Form 306-938

COVER-MOUNTED AGITATOR

Model **207-199**

Parts Change Notice

207-199
COVER & AGITATOR ASSY.

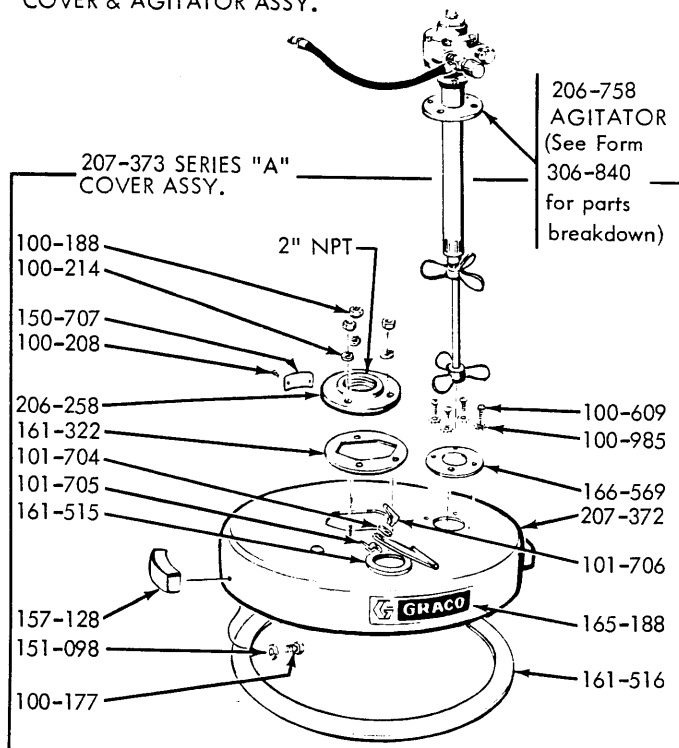
Assembly No.	Series Letter Change	Part That Changed	Ref No.	Part Description	Description of Change
Model 207-199 Cover-Mounted Agitator (also see note below)	—	207-373	none	Drum Cover Assembly	Replaced by Part No. 237-306 Drum Cover Assembly. Refer to manual 308-466 for parts. The following parts are also deleted from the Parts List: 100-177 through 166-569, and 207-372.
Model 206-266 Siphon Tube		150-994	none	Bung Adapter	Replaced by Part No. 176-684 Bung Adapter.

NOTE: The Parts List for 207-199 should include the following numbers only:

206-258 Bung Adapter Assembly

206-758 Agitator Assembly (see manual 306-840 for parts)

237-306 Drum Cover (see the chart above).
